Delegated Report		Analysis she	eet	Expiry Date:	28/06/2022		
		N/A / attached	d	Consultation Expiry Date:	27/06/2022		
Officer			Application Number(s)				
Sofie Fieldsend			2022/1897/P				
Application Address			Drawing Numbers				
9 Maresfield Gardens London NW3 5SJ			See decision notice				
PO 3/4	Area Team Signature	C&UD	Authorised C	Officer Signature			
Proposal(s)

Variation of condition 3 (Approved plans) of planning permission 2016/4136/P dated 11/07/2017 (as varied by 2017/5634/P dated 29/05/2018) (for Excavation of basement extension to existing semi-basement to create four new dwellings comprising 1x 2 bed and 3 x1 bed units and ground floor rear extensions with roof lantern to allow rearrangement of existing dwellings to provide 2 x 3 bed units with rear balcony/terrace and staircases), namely alterations to the front and side boundary wall, landscaping alterations and installation of 5x electric charging points and electric storage unit on front boundary (retrospective).

Recommendation:	Refuse planning permission and warning of enforcement action
Application Type:	Full Planning Permission

Image 1: Existing ground floor plan from ref. 2016/4136/P

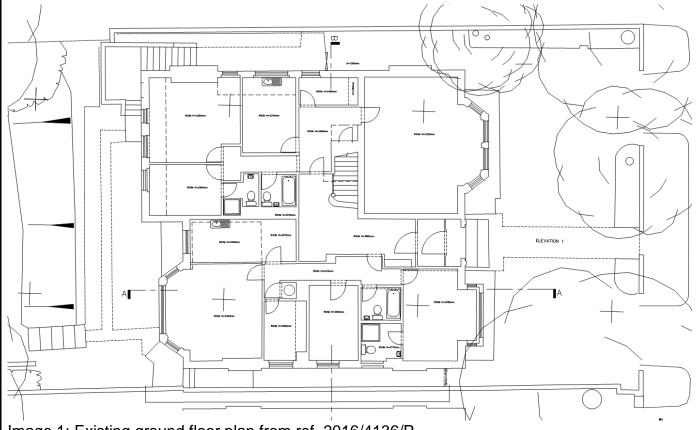
- 3.9 As identified in the conservation statement, the loss of front boundaries and soft landscaping is harmful to the character and appearance of the conservation area. The loss of the original front/side boundary treatment and widening of the existing vehicle access fails to preserve the historic boundary treatment and character and appearance of the Conservation Area. Its partial replacement with a 1.8m high wall along the boundary with Mourne House and installation of a 2m high electric storage unit on front boundary are regarded as incongruous and dominant features which are not in keeping with the historical form of boundary treatment on this road and the wider Conservation Area. The development also results in the loss of soft landscaping along the side boundary with Mourne House and the installation of a much larger bin enclosure and relocation of 10 metre boxes which are highly visible from the street.

- 3.10 As stated above, the proposal has resulted in the existing brick wall being partially demolished and rebuilt in an entirely different character and height. It would be the tallest front boundary within the streetscene and diminish its open character. It would appear at odds with the rest of the character which is low brick walls and detract from the character and appearance of the conservation area. This is considered to be somewhat oppressive when considered alongside the other boundaries on the street, and is particularly noticeable for pedestrians passing.

Image 2: Approved proposed site plan ref. 2016/4136/P

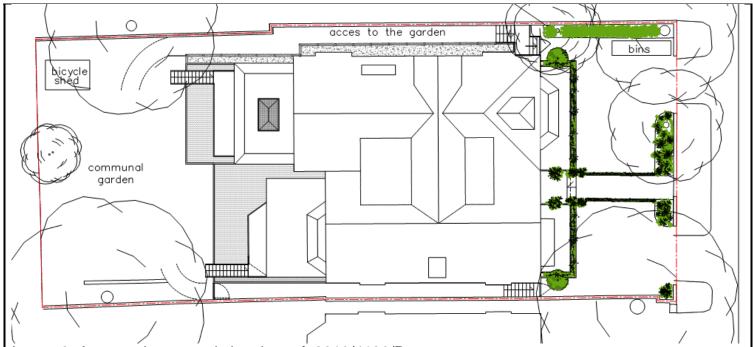
- 5.1 According to the approved plans, the site should have two crossovers and plants along the footpath to delineate the vehicle parking spaces on both sides. With the plants along the footpath, 3 vehicles should be able to park within the driveway comfortably. The retrospective variation application indicates that 5 charging points has been installed, a section of the front boundary has been removed and a mature tree has been removed. Therefore an additional two cars have tried to be accommodated with this retrospective proposal. It should be noted that the 4 new dwellings granted by the original permission were secured as car-free units, no evidence has been provided about which flats now have access to parking within the front garden.

5.6While the provision of charging points is welcomed, 5 charging points is considered to be excessive but they do not increase parking by themselves. The main transport concern is the section of wall which has been removed. The removal the front wall allows easy access for an additional vehicle to park on the driveway, there may also be a possibility of overhanging due to the limited driveway space. The creation of extra on-site parking is not deemed to be essential and contrary to policy which would form a reason for refusal. The loss of the boundary treatment and vegetation would be contrary to Policy T2.

Image 4 – Tree plan.

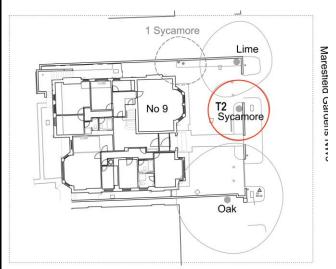
6.1 It is noted that the two sycamore trees shown in image 4 (1 sycamore and T2) within the front garden were given permission for removal under refs 2016/3953/T and 2019/6391/T.

6.2 A section drawing was provided of the boundary wall in proximity to the existing lime tree behind the front boundary wall. The Council's tree officer has assessed the details and conducted a site visit to assess the health of the tree. Given that the height of the wall was increased on top of the existing foundations it is not considered to have had a detrimental impact on the existing trees.
